PLANNING PORTAL REFERENCE: PP-14200817
APPLICATION UNDER SECTION 73 OF THE TOWN AND COUNTRY PLANNING ACT 1990 (AS AMENDED)
AMENDMENT TO PLANNING PERMISSION REFERENCE: 23/0835
AT USKMOUTH POWER STATION, WEST NASH ROAD, NASH, NEWPORT, NP18 2BZ

This application seeks to regularise minor amendments to the approved site layout and accordingly seeks to update the list of approved plans under Condition 1 of the consent.

Figure 1: Extract of proposed layout with fire tanks included (top image); and current approved layout (ref: 23/0835) (bottom image)

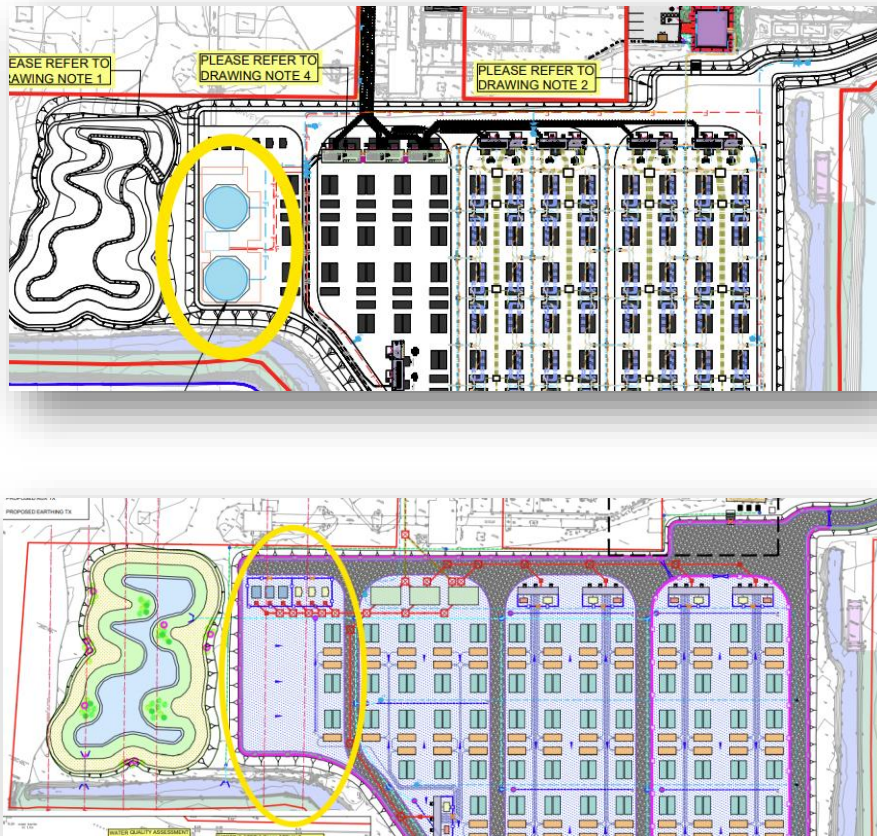
As a result, it is proposed to install 2no. bespoke fire water tanks in the western part of the battery compound itself. The fire tanks extend to 2.77m height and 13.95m diameter will each have a net capacity of 338m³, integrated into a below ground sprinkler system network, to ensure the fire safety of the site. They will be positioned on a concrete base and a pump house enclosure will be installed between the two tanks (see Figure 1 overleaf).

The fire tanks are made of galvanised steel and will be painted green, to match the RAL colours of the battery units, which will help to visually integrate them into the site and surroundings. The fire pump house will be painted the same green colour. Ultimately, the form, scale and design of the fire tanks is in keeping with the industrial nature of the BESS site and wider Uskmouth site.

The tanks will be positioned within the approved perimeter fence for the BESS compound and will extend to a height of 2.77m. As a result, the fire tanks will be no more visually imposing than the approved battery units (which are 3m height) and will benefit from the visual screening of the boundary fence.

Figure 3: Proposed amendment to northeastern extent of BESS compound (shown left), to avoid existing structure (shown right)

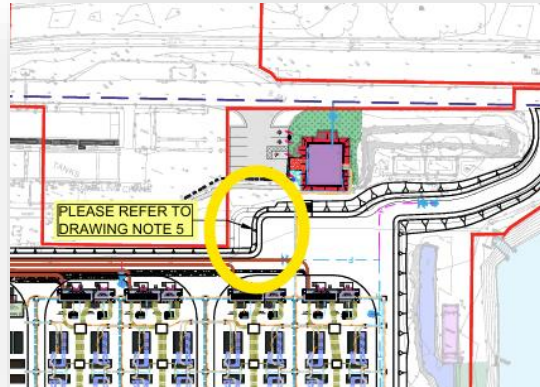
Slight amendments are proposed to the extent of the BESS plateau. In the north eastern corner, the extent is to be shifted eastwards to avoid interfering with an existing coal hopper chute (see figure below).
